SERVICE DIRECTIVE BULLETIN

SERVICE NOTE NO. 0018
Supplement A

SERVICE NOTE NO. 0018

Subject: Premature Failure of Idler Yoke P/N 28-13223 (Forging)

The illustration below shows the forged idler yoke installation.

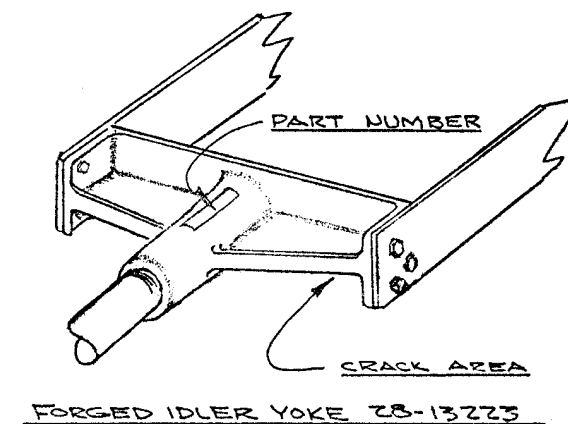
Reports of premature failures of the forged idler yoke P/N 28-13223 in the field have been received. These failures occurred at an average service time of approximately 88 hours. Identification of the forging can be accomplished by the following:

1. The part number is imprinted $\frac{1}{4}$ -inch raised numbers on the barrel portion.
2. The opposite side of the barrel has the alloy number MMT2014 in raised letters.

Helicopters prior to Serial No. 154 had a cast component P/N 28-13223 installed and are not affected by this service note. Helicopters that may have had this idler yoke (P/N 28-13223) changed by maintenance should be checked to verify if a cast or forged component is installed.

The cast component P/N 28-13223 will not have the raised part number or the alloy number imprinted on it, and will have a "T" cross section with a rough finish.

It is mandatory that immediate dye penetrant inspection of the forged P/N 28-13223 be performed and a close visual inspection be made on preflight or daily basis. The dye penetrant inspection is to be repeated every 10 hours until further notice.
